PUBLIC SCOPING

Subject: Notice of Intent/Notice of Preparation of a Draft Environmental Impact Statement/
Environmental Impact Report (SCH#2013092010) for the South Bay Salt Pond
Restoration Project, Phase 2

SUBJECT: Notice of Preparation for the South Bay Salt Pond Restoration Project, Phase 2
Draft Environmental Impact Statement/Environmental Impact Report (EIS/EIR)
SCH No. 2013092010

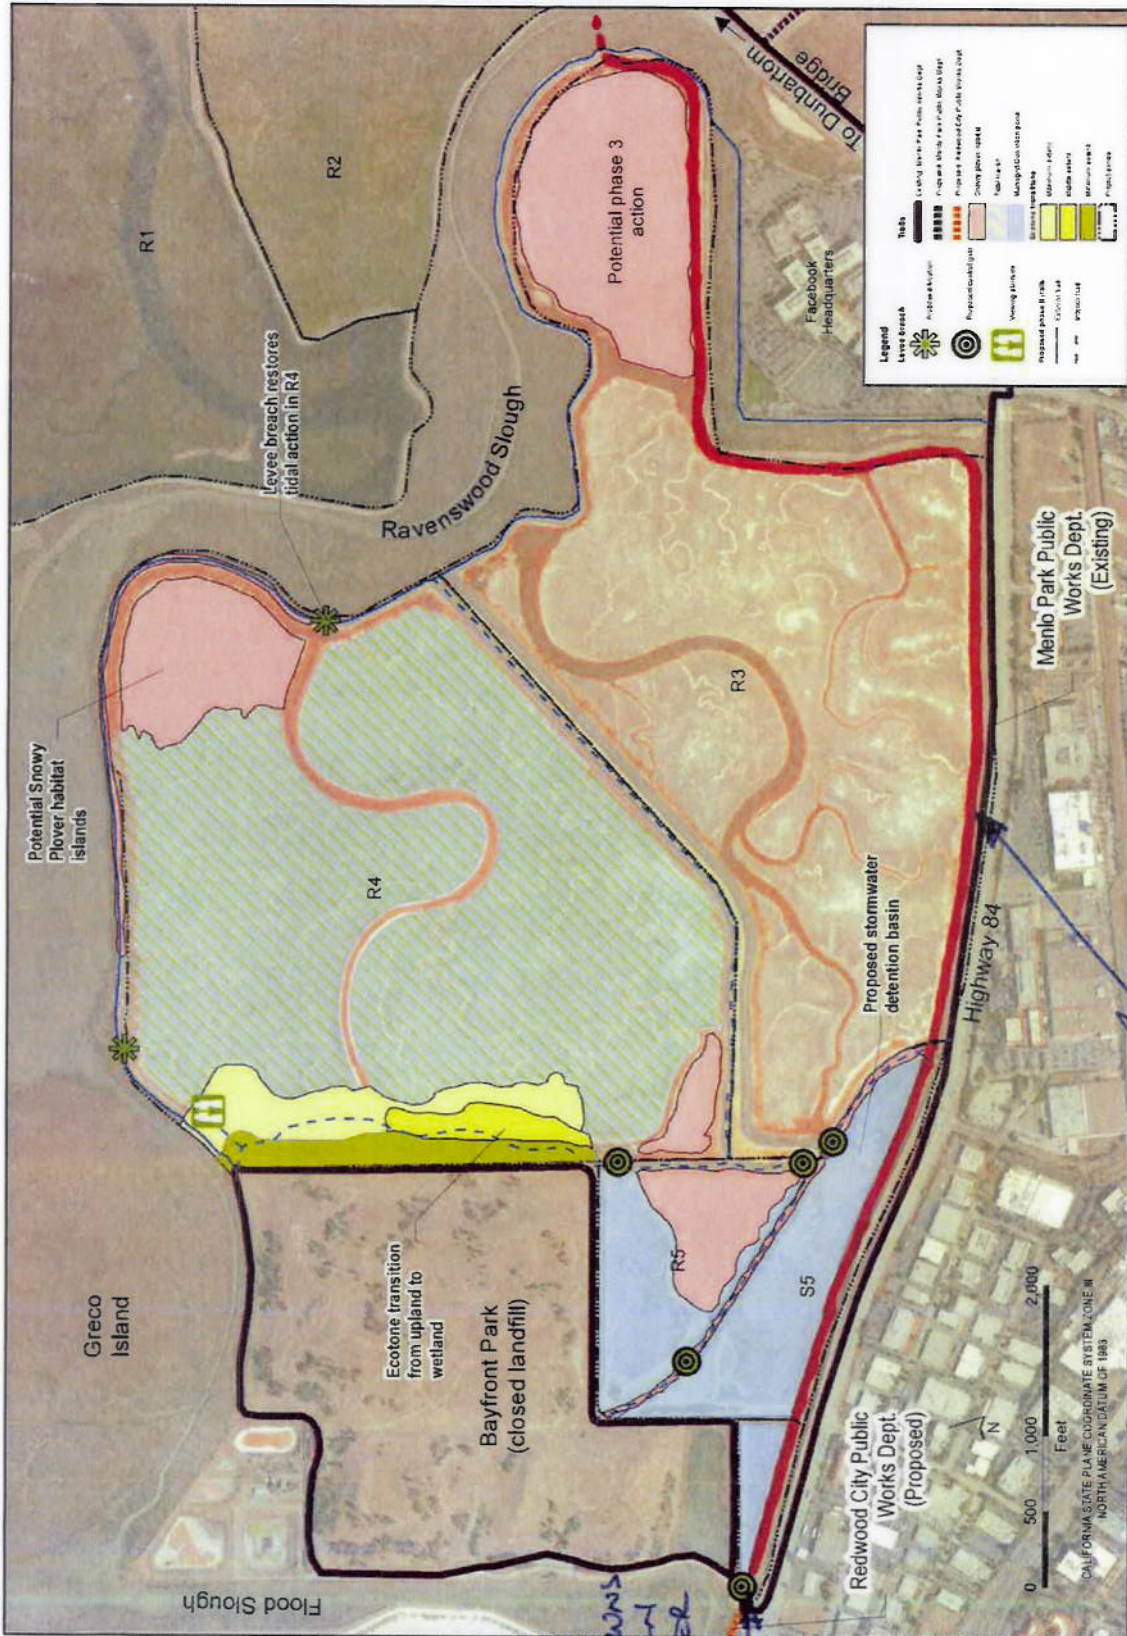
1. The first attachment includes Figures 1 and 2 from the Opportunities and Constraints for Ravenswood Pond Complex Report dated June 28, 2012 by URS Corp. Figure 1 identifies Cargill's Salt Plant Site as a "Non-project pond". Please have URS remove the shading on Cargill's Salt Plant Site and remove it from the maps legend as it has no bearing on the project and it outside the Project Area. I have provided some notes on Figure 2 from the same document to show Cargill's ownership and/or rights within the Project Area. Please make sure these are identified and considered within the Phase II planning process.

REMOVE FROM LEGENDS

REMOVE SHADING →

Figure 5
Ravenswood Ponds

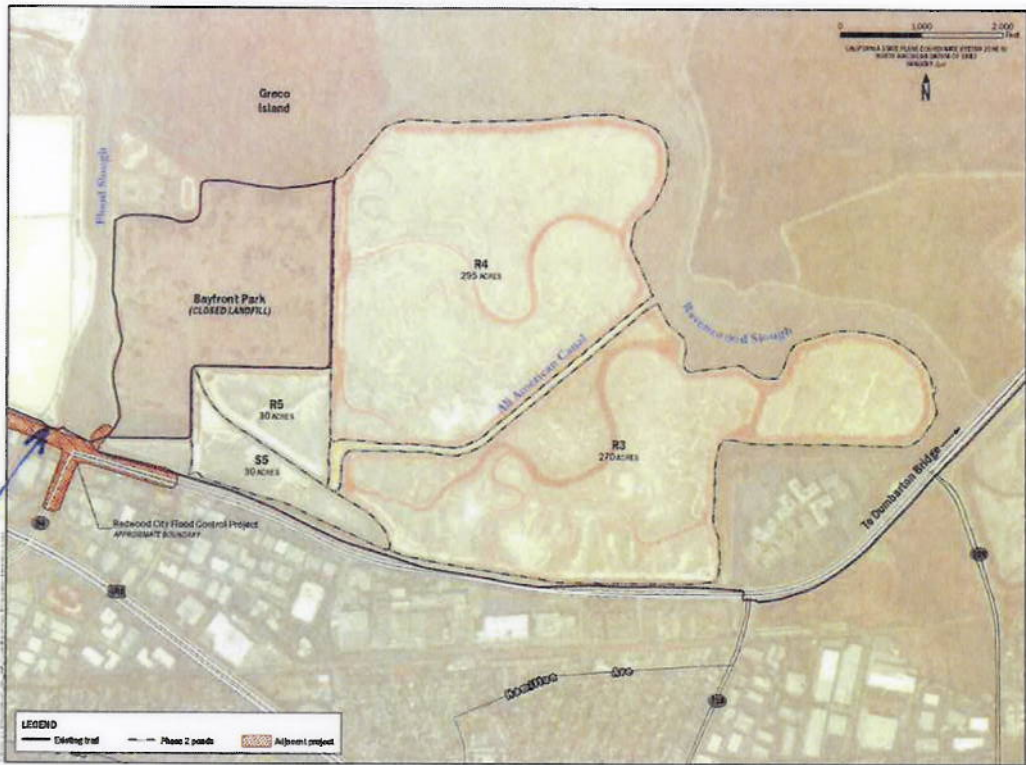
2. The second attachment includes Figure 5 from the Phase II Ravenswood Map and the Phase 2: Eden Landing Handout. Figure 5 generated by URS shows an "existing trail" continuing onto Cargill's Salt Plant Site. Please have URS remove this trail section as it does not exist. The Phase 2: Eden Landing Handout map generated by URS shows a Phase II trail along the eastern levee of Cargill's Pond 3C. It should be noted that this section of trail needs to be in cooperation with Cargill or located elsewhere.

CARGILL OWNS
 THE WESTERN
 MOST CORNER
 OF S5

CARGILL PIPELINE AND 10 FT. WIDE
 FEE OWNERSHIP STRIP.

**Phase 2: Eden Landing
Handout, Stakeholder Forum/Working Groups 11-15-12 Meeting**

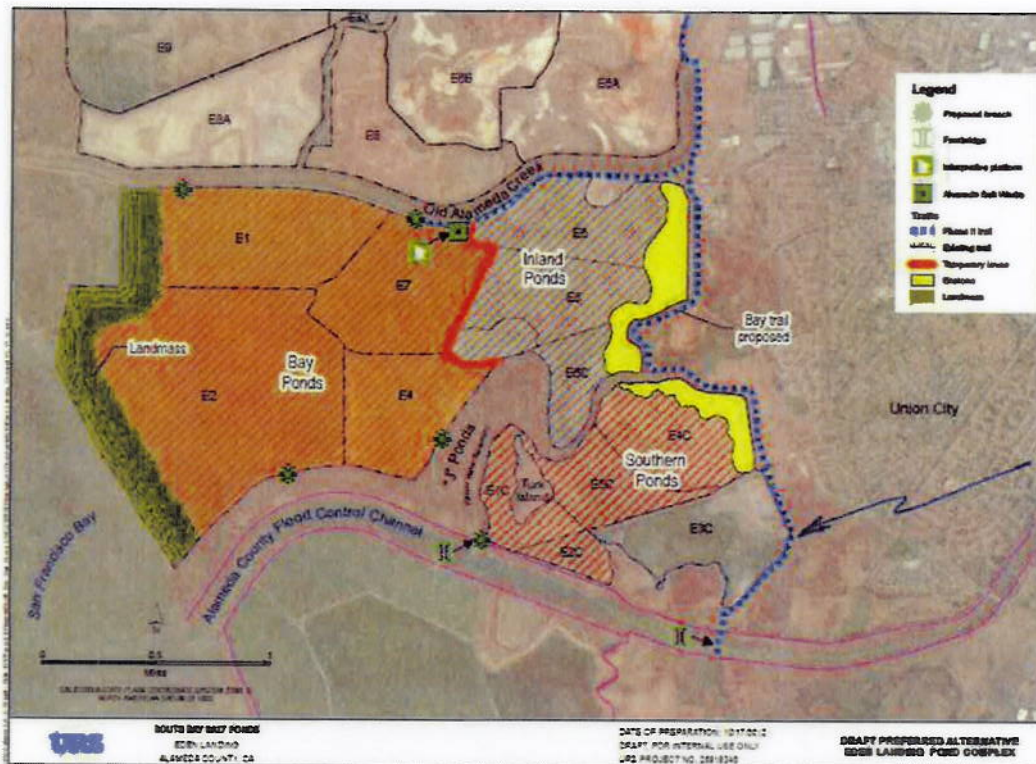
LEVEE OWNED BY CARHILL. PUBLIC ACCESS TO BE PROVIDED ELSEWHERE OR BY OTHERS
